Model: 7100

RECOVERY TANK REPLACEMENT KIT

NOTICE: Machines Manufactured before S/N 10130121

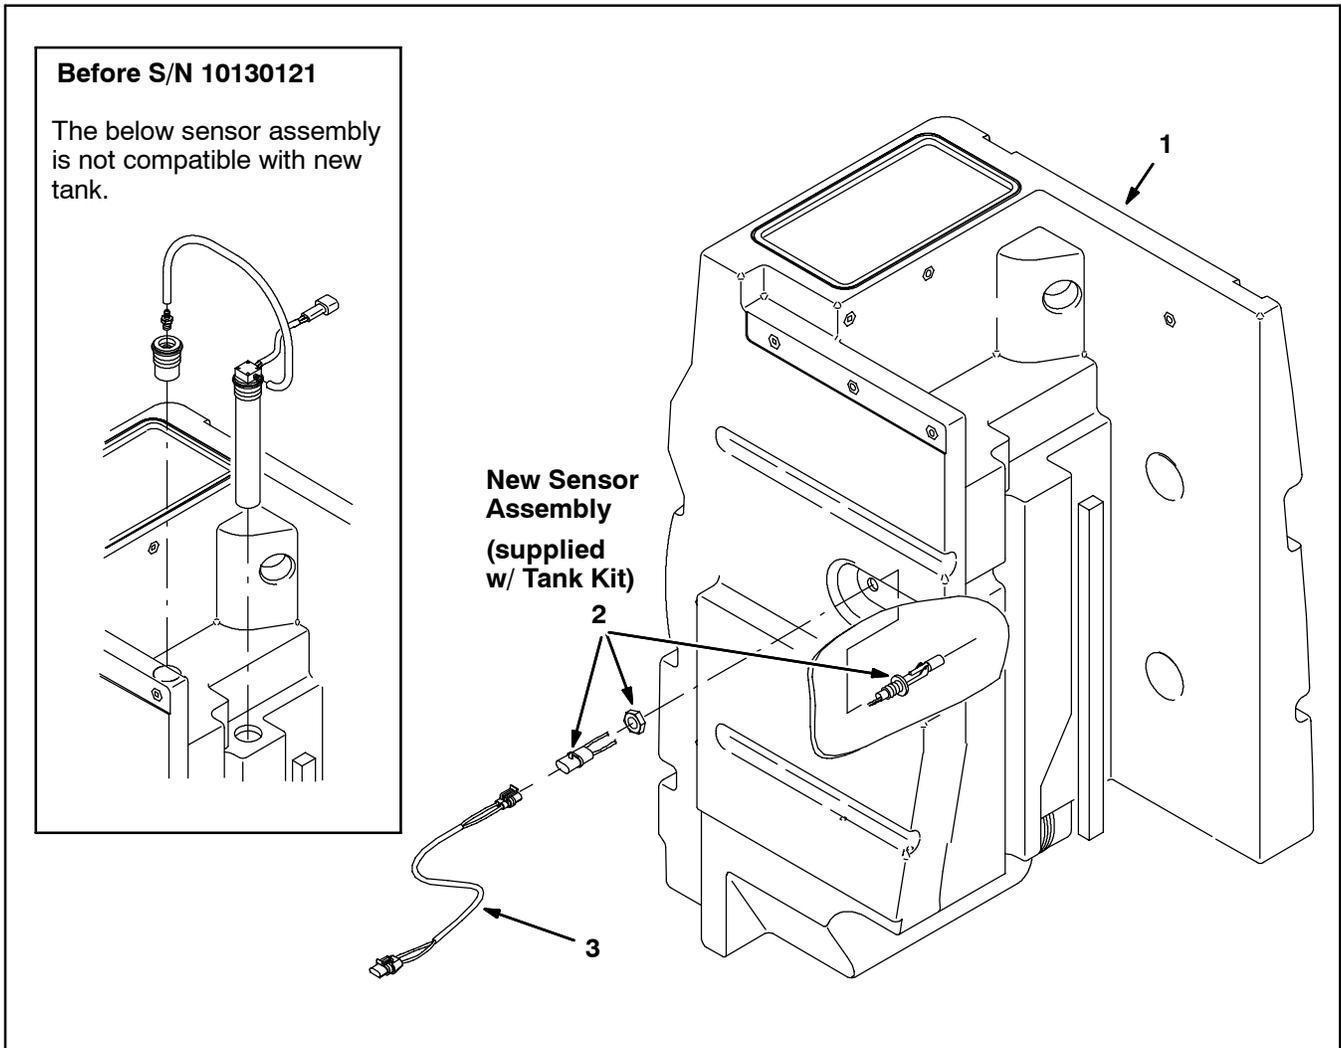
If the machine was manufactured before serial number 10130121, you will need to replace the liquid level sensor with the new sensor assembly supplied with kit. The new tank is not compatible with old style sensor. Install new sensor assembly as illustrated below.
